Subject: Transnuclear, Inc. (TN) Application for the TN-40 Transportation Packaging for Spent Fuel, Revision 3, Docket No. 71-9313, TAC No. L24106

Reference: Letter from Meraj Rahimi (NRC) to Robert Grubb (TN), "Second Round Request for Additional Information for Review of the Model No. TN-40 Transportation Package," dated January 29, 2009

This submittal provides responses to the request for additional information (RAI) forwarded by the referenced letter. Enclosures 4 and 5 herein provide each of the NRC staff RAI followed by a TN response for non-proprietary items and proprietary items, respectively. Enclosure 2 lists the RAI items and shows associated changed Safety Analysis Report (SAR) page numbers.

Figure 2-8.1 – TN 40 Shell Flange, Nodal Stress Intensity Distribution for A12 (Cold)

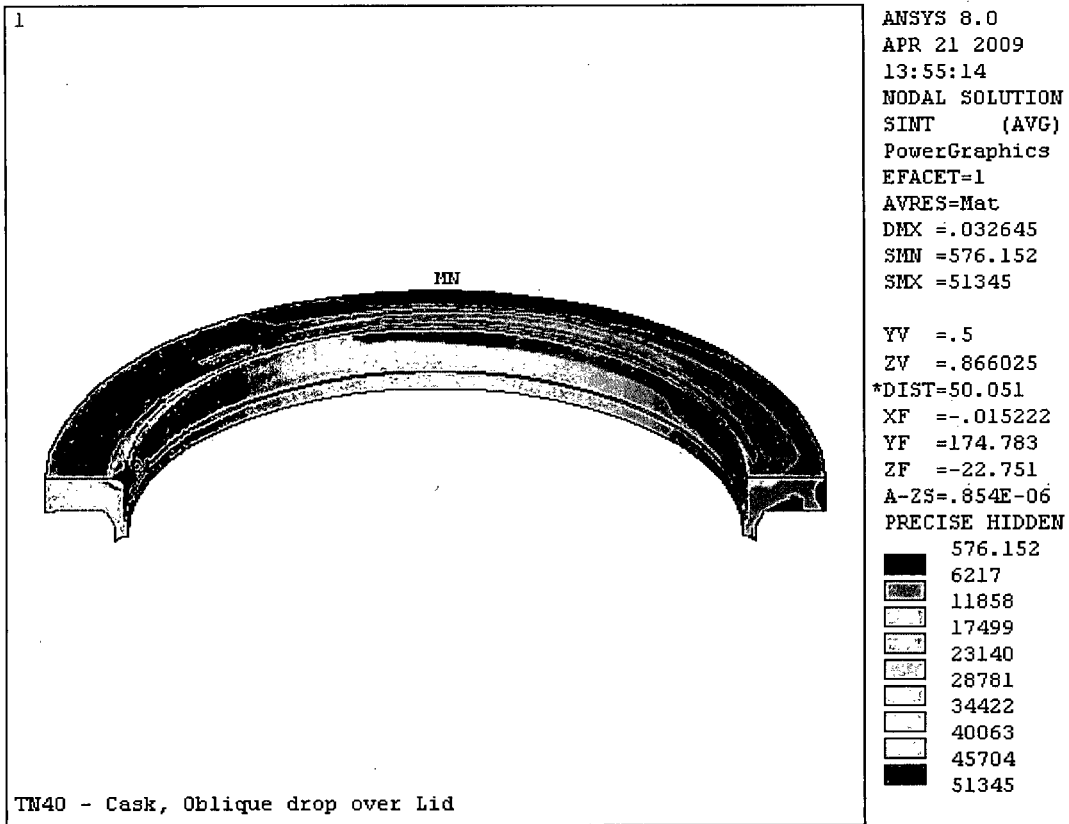
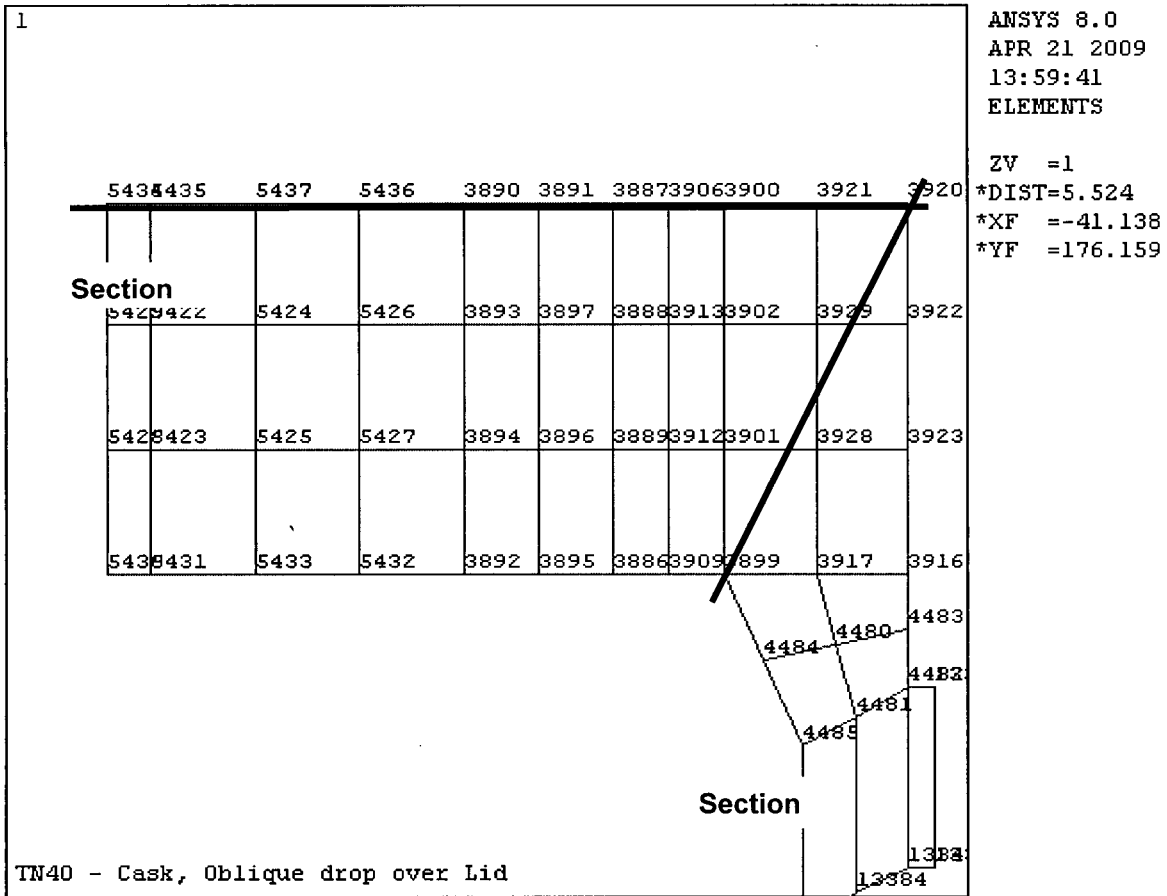
2-8 Verify that the cross section is appropriately selected for evaluating the maximum stress intensity for the containment boundary shell flange for the load combination Case A12, which includes the cold, 30-ft slapdown drop event.

The nodal stress intensity distribution in the shell flange for load combination Case A12 is shown in Figure 2-8.1 below. This load combination includes the cold, 30-ft slapdown drop on lid event. The figure shows that the maximum nodal stress intensity of 51.35 ksi occurs at node number 3920 located at the flange inner diameter corner. Flange node numbers at a section through 3920 are shown in Figure 2-8.2. The two cross sections from the highest stress intensity node 3920 shown in Figure 2-8.2 are considered bounding. One cross section is defined by nodes No. 3920 and No. 5434 and other cross section is defined by nodes No. 3920 and No. 3899. Stresses are linearized at both of the cross sections. The stress linearizing details at these two cross sections is given in Tables 2-8.1 and 2-8.2 below. A summary of stress intensities is given below:

It is seen from above that cross section 1, defined by nodes No. 3920 and No. 5434, has the higher stresses and was therefore appropriately selected for reporting shell flange stresses in SAR.

Figure 2-9.1

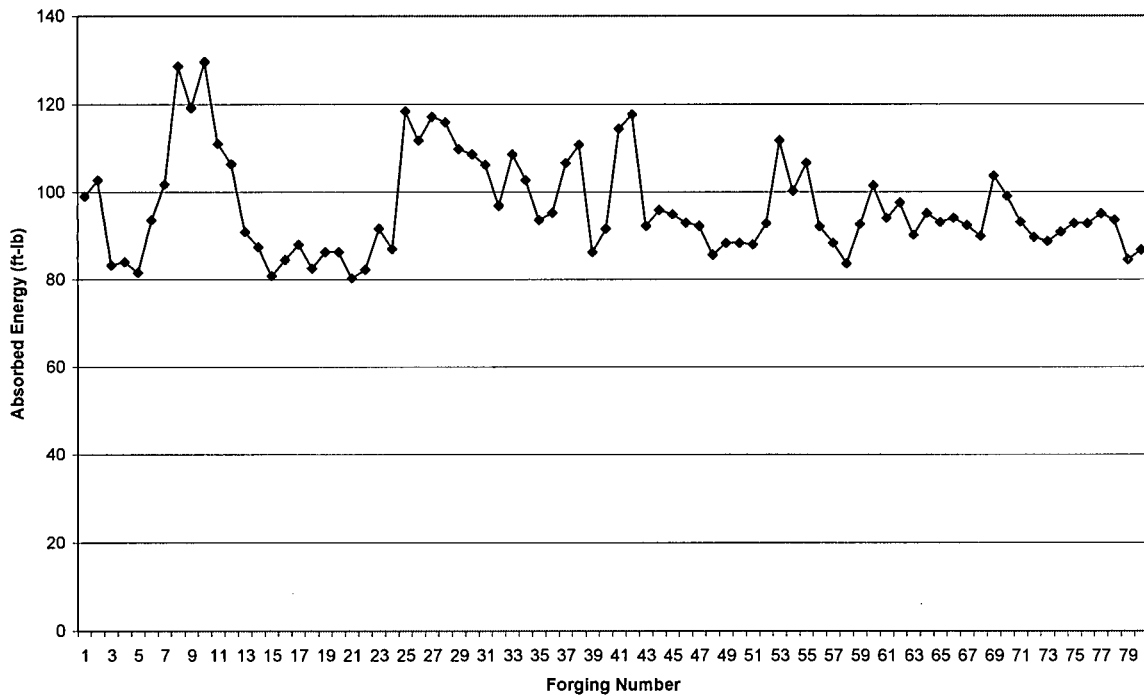
- 2-9 Provide justification that the testing, using a limited combination of potential base metals, filler materials, and weld techniques (2 tests), bounds the worst case fracture toughness expected from all potential combinations of these three parameters. Explain why TN fabricators chose the combination of weld processes, electrodes, and base material presented in the table to demonstrate the toughness of the weld and heat affected zone (HAZ). Defend why the table data are representative of all other possible combinations which can be used, or are these data the best case scenario?

For current procurement, each TN-68 Shield Shell is fabricated from two forgings. Fracture toughness test results (-20F Charpy V-notch testing) for forty forgings is available and shown in Figure 2-9.1.

The average test result for the forty TN-68 Shield Shells at -20°F was 96.6 ft-lb with a standard deviation of 11.3 ft-lb. The TN-68 results are both much higher (over five times) than the TN-40 requirement of 18 ft-lb and very consistent. 18 ft-lb equals the average TN-68 result minus nearly seven standard deviations. These results strongly support the conclusion that the fracture toughness properties of the TN-40 Shield Shells exceed the minimum required by a margin which can safely accommodate any realistic variations in chemical composition and physical processing as well as the effects of welding.
